SUFFOLK COUNTY PLANNING COMMISSION
c/o Suffolk County Department of Economic Development & Planning
100 Veterans Memorial Highway, PO Box 6100, Hauppauge, NY 11788-0099
T: (631) 853-5192 F: (631) 853-4044
Joanne Minieri, Deputy County Executive and Commissioner, Department of Economic Development
and Planning
Sarah Lansdale, Director of Planning

NOTICE OF MEETING

STAFF REPORT

Applicant: Wyandanch Revitalization Communities A, LLC
Municipality: Babylon
Location: E/S/O County Road 2 (Straight Path) ~ 500' N/O Main Street
Received: 2/21/13
File Number: BA-09-01.1
T.P.I.N.: 0100 04000 0100 006000 (sic)
Jurisdiction: Adjacent to CR 2 (Straight Path)

Z-1: North Isle Village STP
SCP No.: BR-13-01
SCTM No.: 0200-315.00-01.00-001.000

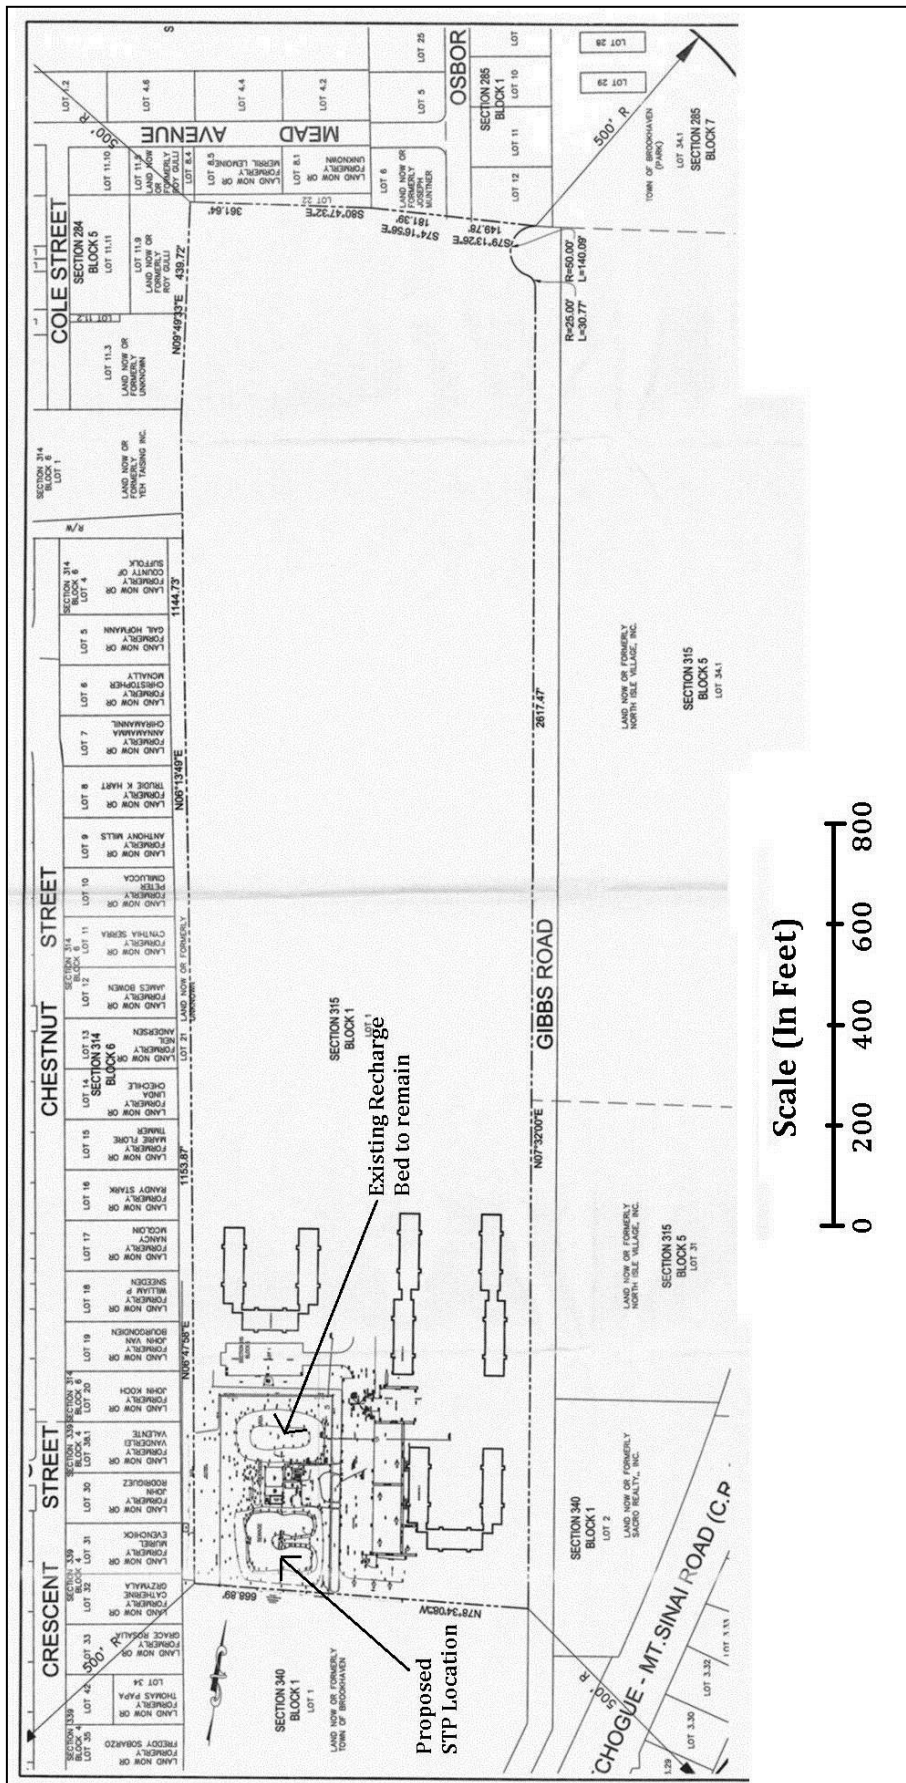
1. Dialogue should commence and continue as is necessary for permits and approvals with the Suffolk County Department of Health Services and the Department Public Works.
2. The Town Planning Board and the applicant should review the Suffolk County Planning Commission publication Managing Storm Water-Natural Vegetation and Green Methodologies and incorporate where practical natural remedies for storm water runoff treatment.

Z-4: Avalon Bay at Huntington Station
 SCPD No.: HU-11-01
 SCTM No.: 0400-104.04-02.00-001.000 et al.

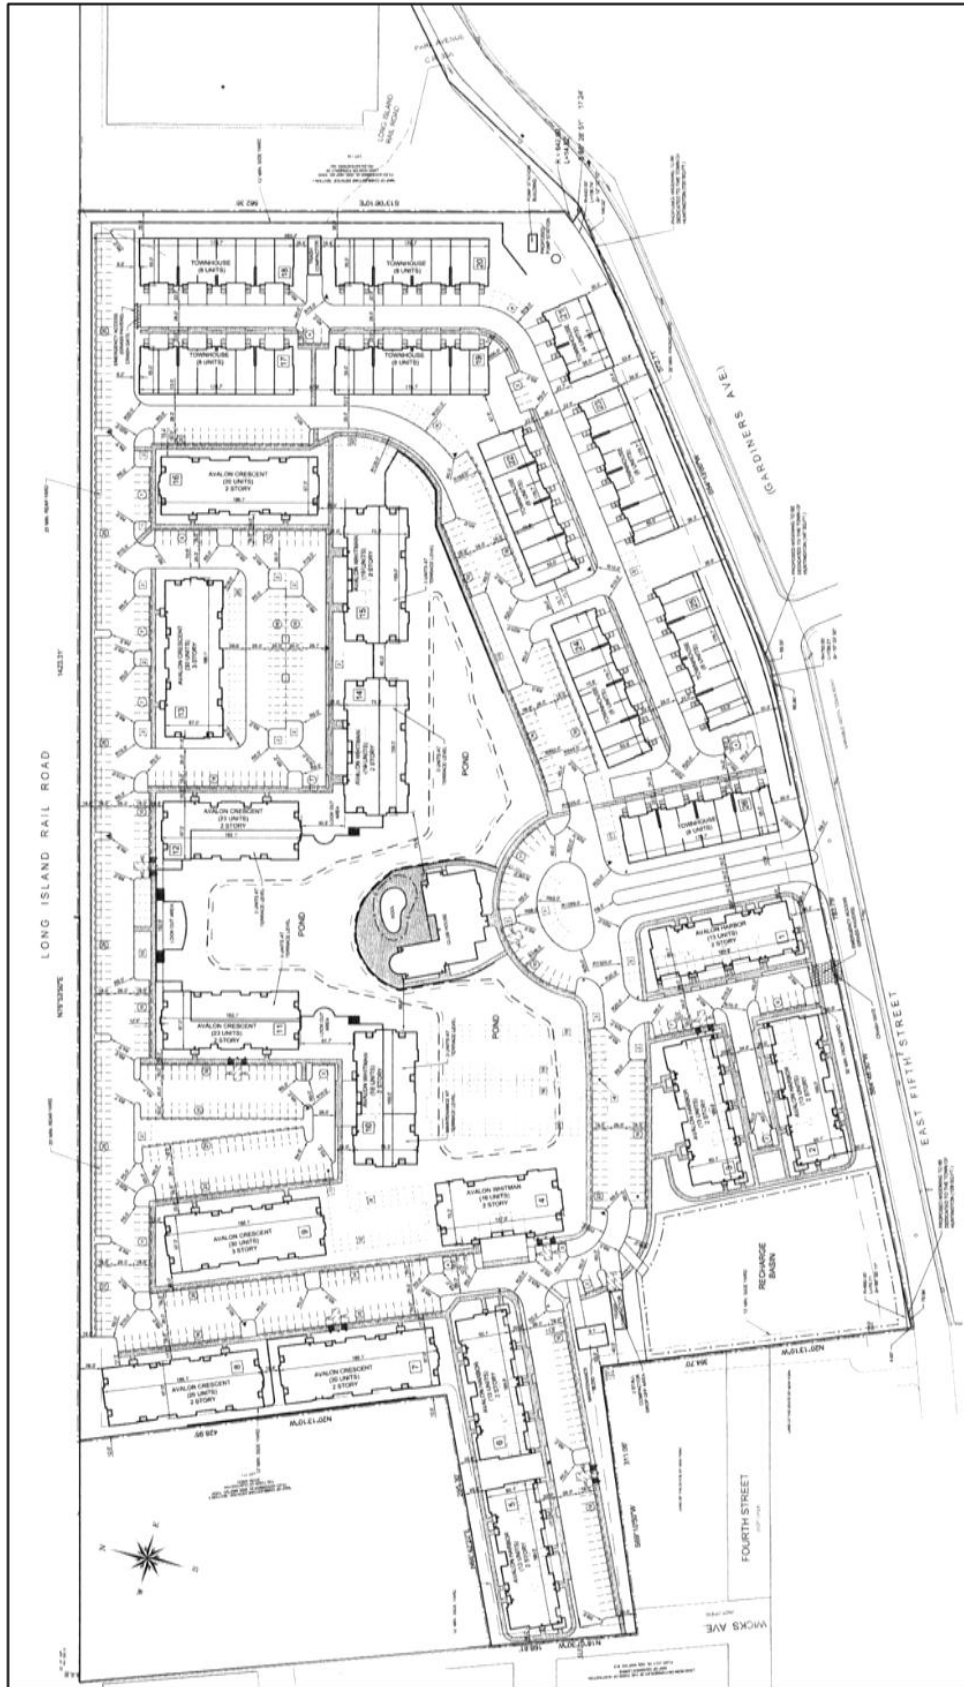
2. The proposed density of 14.2 units per acre is well above the Town average (5.1 units per acre), well above the average for Huntington Station (9.5 units per acre) and well above the average density surrounding the subject parcel. The density of the proposed project also raises concerns with respect to potential traffic impacts, the ability to meet on-site parking demands and proximity to the train station.

Therefore, it is recommended that the Town consider a reduction in density more consistent with the nature and character of development in the area and the Town as a whole based upon an analysis of garden apartment density throughout the Town. This will also help to insure that adequate parking can be provided on site and traffic impacts may be appropriately mitigated.

3. The percentage of rental units within Huntington Station is the highest of any Hamlet in the Town (30%) and the percentage of multiple-family rental units is the second highest of any Hamlet in the Town (59%). The applicant is proposing to maintain eighty percent of the proposed units (303) as rental units with the remaining twenty percent (20%) of units (76) as ownership units.

Therefore, it is recommended that consideration be given to increasing the percentage of ownership units for the project in order to insure that there is an appropriate diversity of housing types within the community. It is recommended that the Town conduct a town-wide analysis of the distribution of ownership-rental units in order to address this issue.

5. Landbanked parking located within the proposed ponds makes little sense and will be impractical to implement. The location of parking spaces within the planned on-site garages also raises concerns due to the tendency to utilize garages over time for storage purposes resulting in a loss of on-site parking. The proposed parking plan should be revised to eliminate both landbanked parking within the ponds and parking within the proposed garages while still insuring that parking is provided in accordance with code requirements or that any relaxation is properly addressed.
